Access Compliance Report

Public Rights-of-Way

(Pedestrian Signals)

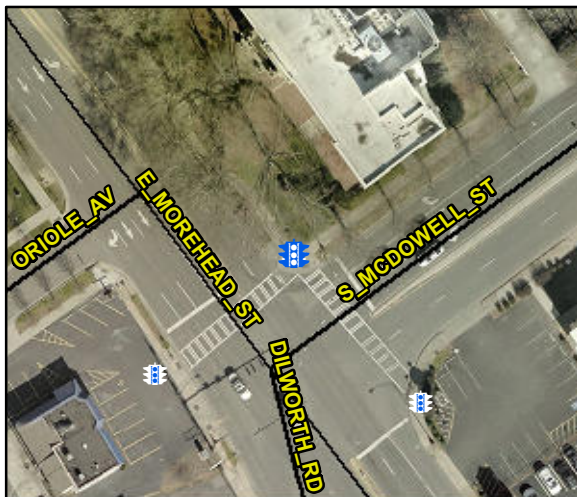
Intersection ID: N/A	Main Street:	Cross Street: N/A	Location: N/A
ADA ID: DB6FE971ABFE	Signal Type: Two Push Buttons-Non APS	Overall Compliance: No	Severity Score: BTN 1:N/A BTN 2: N/A No BTN: N/A
Codes/Mitigation Info/Possible Solution		Field Measurements/Component Compliance

PROW/ADA: TMUTCD 4e.08, R404.2, R406.2, R404.3

Compliance	Description	Data	Compliance	Description	Data
	Button Count	Button2	N/A	Distant to Additional Button (in)	N/A
	Additional Button Present?	No		Additional Button ID	N/A
N/A	Signal Buttons Required?	N/A	N/A	Additional Ped Posts Required	N/A
	How Many Ped Street Xings?	2		Located In An Island/Median?	No
N/A	B 1 Sign Present?	Yes	N/A	B 2 Sign Present?	Yes
Yes	B 1 Sign Purpose?	Yes	Yes	B 2 Sign Purpose?	Yes
Yes	B 1 Sign Lettering & Contrast?	Yes	Yes	B 2 Sign Lettering & Contrast?	Yes
Yes	B 1 Parallel To XWalk?	Yes	Yes	B 2 Parallel To XWalk?	Yes
Yes	B 1 PAR to Button?	Yes	Yes	B 2 PAR to Button?	Yes
Yes	B 1 PAR to XWalk?	Yes	Yes	B 2 PAR to XWalk?	Yes
Yes	B 1 Clear Floor Space?	Yes	Yes	B 2 Clear Floor Space?	Yes
N/A	B 1 FWD Approach?	Yes	N/A	B 2 FWD Approach?	Yes
N/A	B 1 FWD Approach Constrained?	No	N/A	B 2 FWD Approach Constrained?	No
No	B 1 FWD Approach Reach (in)	9.0	No	B 2 FWD Approach Reach (in)	10.0

N/A	B 1 FWD Approach Width (in)	N/A	N/A	B 2 FWD Approach Width (in)	N/A
N/A	B 1 FWD Approach Obstruction?	Yes	N/A	B 2 FWD Approach Obstruction?	Yes
N/A	B 1 FWD Approach Obstruction Dist (in)	8.0	N/A	B 2 FWD Approach ObstructionDist (in)	9.0
N/A	B 1 PARA Approach?	Yes	N/A	B 2 PARA Approach?	Yes
N/A	B 1 PARA Approach Constrained?	No	N/A	B 2 PARA Approach Constrained?	No
Yes	B 1 PARA Approach Reach (in)	9.0	Yes	B 2 PARA Approach Reach (in)	10.0
N/A	B 1 PARA Approach Width (in)	N/A	N/A	B 2 PARA Approach Width (in)	N/A
N/A	B 1 PARA Approach Obstruction?	Yes	N/A	B 2 PARA Approach Obstruction?	Yes
N/A	B 1 PARA Approach Obstruction Dist (in)	8.0	N/A	B 2 PARA Approach ObstructionDist (in)	9.0
Yes	B 1 Clear Floor Space Slope (%)	0.5	No	B 2 Clear Floor Space Slope (%)	9.2
No	B 1 Clear Floor Space XSlope (%)	9.3	No	B 2 Clear Floor Space XSlope (%)	2.8
N/A	B 1 PAR Slope (%)	3.7	N/A	B 2 PAR Slope (%)	4.5
Yes	B 1 Height (in)	43.0	Yes	B 2 Height (in)	42.0

Yes	B 1 Clear Xing Direction?	ClearlyMarked	Yes	B 2 Clear Xing Direction?	ClearlyMarked
	B 1 Crossing Direction	To SW		B 2 Crossing Direction	To SE
Yes	B 1 DistanceTo XWalk (in)	12.0	Yes	B 2 DistanceTo XWalk (in)	0.0
No	B 1 DistanceTo Curb (in)	168.0	No	B 2 DistanceTo Curb (in)	180.0
Yes	B 1 Diameter (in)	2.0	Yes	B 2 Diameter (in)	2.0

Possible Solutions: Replace Signal Push Button With APS Button on New Post. Remove & Relocate Sign.
